## The Corporation of the District of Saanich

# Report

**Subject:** Subdivision and Development Variance Permit Application

**File:** SUB00942; DVP00521 • 2660 and 2670 MacDonald Drive East

**Figure 2: Proposed Boundary Adjustment Subdivision (from plans by Powell and Associates)**

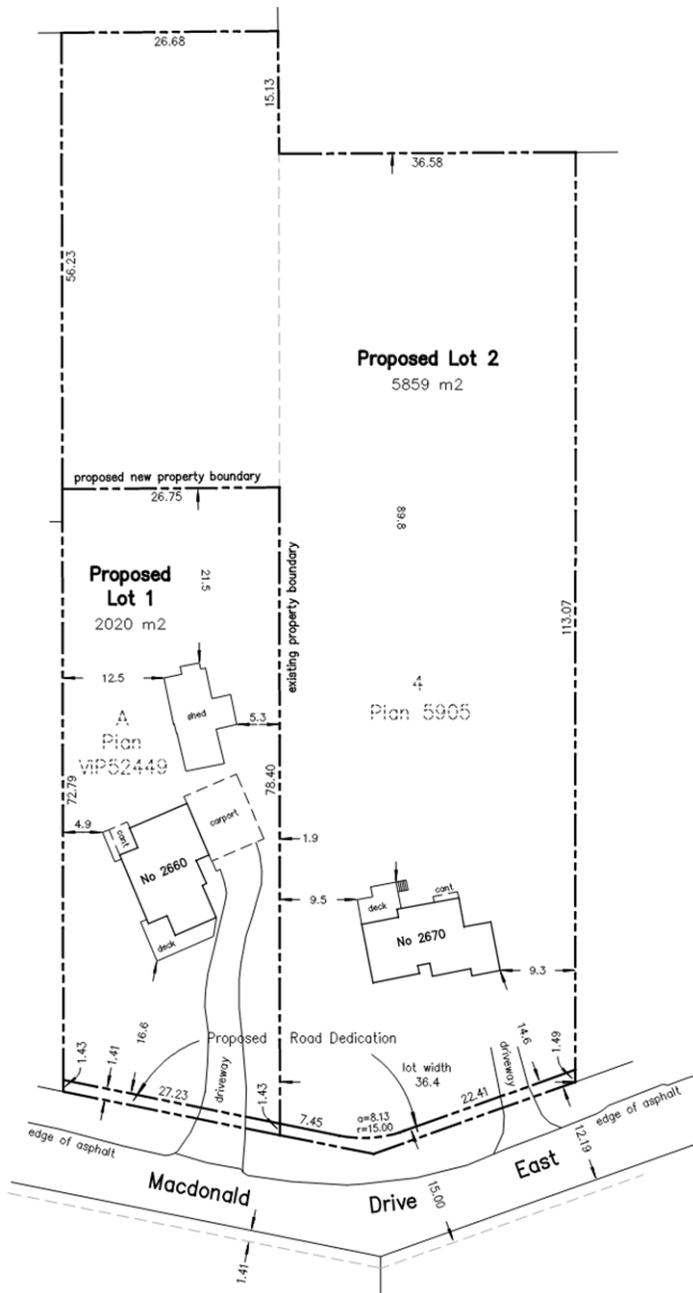
**Lot width**  
 The RS-14 (Single-Family Dwelling) Zone has a minimum lot width requirement of 30 m. Proposed Lot 1 would have a lot width of 26.75 m, requiring a variance of 3.25 m. The lot width of proposed Lot 1 is the same as when the lot was originally subdivided in 1946 (see Figure 4), however because these are considered new lots the current Zoning Bylaw lot width requirement applies, and a variance is required. The lot width variance is minor and is not anticipated to impact the liveability of future owners, neighbouring properties, or the streetscape. The variance to lot width does not impact the viable building envelope on the proposed lot. The requested variance can be supported.
